# Contingency Modeling Enhancements

## Comments on Issue Paper as of May 15, 2013

**Figure 1 - Implied Supply and Demand for Corrective Capacity**

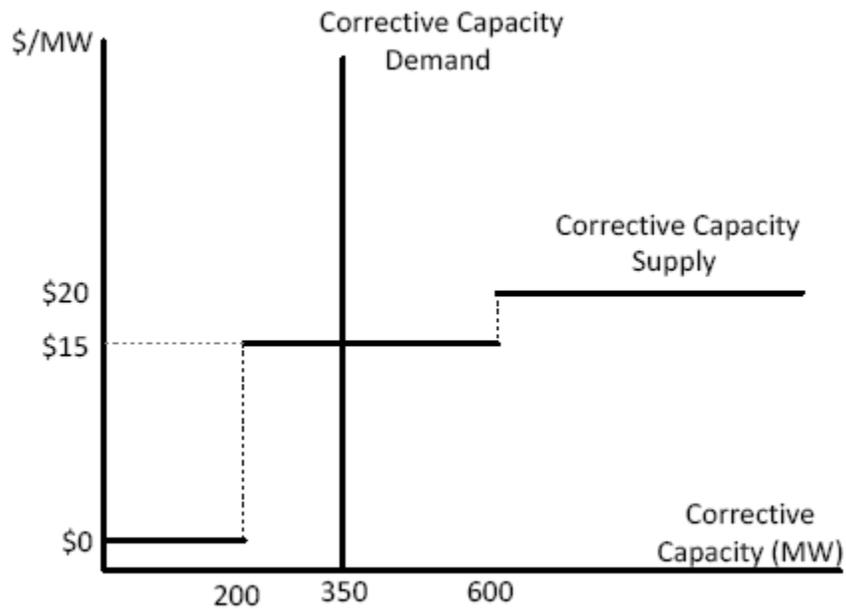
DMM believes that resources should be compensated for the value their corrective capacity provides to the ISO system. The LMCP, as described in the technical paper, correctly prices the corrective capacity at its locational marginal value.

It is important to note that the LMCP is not simply the opportunity cost of corrective capacity. It is derived from the shadow prices on corrective constraints, which are the amount that system costs would be reduced if the constraint were relaxed by one MW.

If the shadow price is set by a resource reducing energy sales in order to provide corrective capacity, the shadow price will represent the marginal cost to the system of this forgone production, which by definition will cover opportunity cost of the resource. If the shadow price were set by the marginal cost of reducing flows across a constraint, it would represent the cost of re-dispatching to reduce flows. In this case, any resource that does forego energy production will still have its opportunity cost at least covered by its LMCP. In all cases the LMCP will represent the marginal value of corrective capacity at that location.

To illustrate, consider the first example from the technical paper (starting on page 12). The demand for corrective capacity is the preventive line limit minus the corrective limit, 350 MW. The supply of corrective capacity is the marginal cost of providing the corrective capacity.<sup>2</sup> G2 can provide up to 200 MW for \$0/MWh, G3 can provide up to another 400 MW for \$15/MWh, and the flows on the line can be reduced at a cost of \$20/MWh for another 550 MW. Figure 1 shows the supply and demand curves for corrective capacity. The market value of corrective capacity is the \$15/MWh LMCP. Even though the G2 corrective capacity has zero marginal costs, it does have positive marginal benefits. If the last MW of corrective capacity G2 provided was not available then system energy costs would increase by \$15. If G2 were to provide one more MW of corrective capacity then system energy costs would decrease by \$15. Compensating G2 for corrective capacity aligns its incentives to increase capacity, and thus receive more capacity payments, with minimizing system costs.<sup>3</sup>

The ISO agrees with DMM's comments and is of the position that the preventive-corrective constraint should allow for compensation at the LMCP, which will be paid to all resources at each location. This is because the LMCP reflects: 1) a resource's opportunity costs; 2) marginal congestion cost savings; and/or 3) the marginal capacity value to follow dispatch (see Section 7.3.2).

Figure 1: System in CAISO's example

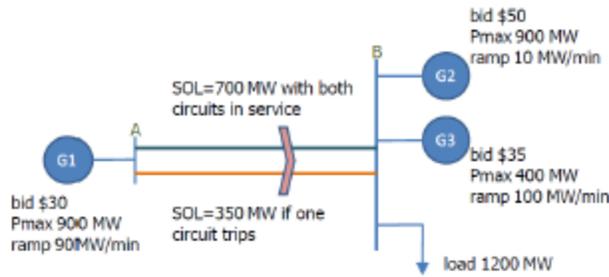
Very likely, contradictory to its intent, the CAISO's current proposal will not incentivize flexible capacity and fast ramping resources. SCE illustrates this point with examples.

Under the CAISO's proposal, the solution is to dispatch G2 at 250MW and G1 at 250MW. The "corrective capacity" for G2 is 200MW and for G1 is 150MW. As shown in Table 3 in the issue paper, also duplicated below, G2 will receive a revenue of \$12,500 for the 250MW energy dispatch, and a revenue of \$0 for its "corrective capacity" (based on opportunity cost) or a revenue of \$3,000 for its "corrective capacity" (based on locational capacity-energy mixed price). The total revenue for G2 will be at least \$12,500.

See section 7.4.1. The ISO's nodal electricity market clears all products at marginal prices. For example, LMP is the marginal cost of serving extra load at a location, and a constraint shadow price is the marginal cost saving of extra transmission capacity. A marginal price only holds its value for a limited parameter change, and may not hold the same value when a big change is introduced into the market. For example, the LMP may change when an extra unit is committed, and the transmission shadow price may diminish if there is a major transmission upgrade. The example demonstrated above involves changing G2's ramp rate from 10 MW/min to 20 MW/min, which is equivalent to increase the 20-minute ramping capability by  $10 \times 20 = 200$  MW. With such a big change, the LMCP diminishes because the total supply exceeds the SOL demand 350 MW. This does not mean the LMCP does not provide the correct incentive. To the contrary, this means the incentive that LMCP provides is not only correct in encouraging investment, but also correct in discouraging over investment.

Figure 2: Same system except now G2 has improved its ramp rate

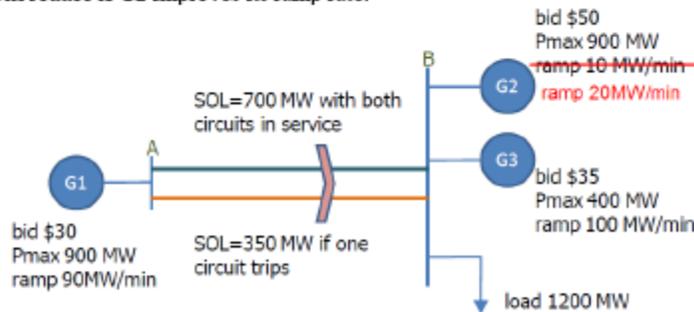
Under the CAISO's solution, there would be no incentives for G2 to advance its technology and improve its ramping rate. The limited ramping capability of G2 contributes to the problem and if G2 were to improve that ramping, the problem may not exist, hence, G2 would not be paid. To illustrate the point, below is a scenario to show that the revenue of G2 will reduce if G2 improves its ramp rate.

**Scenario: G2 improves its ramp rate**
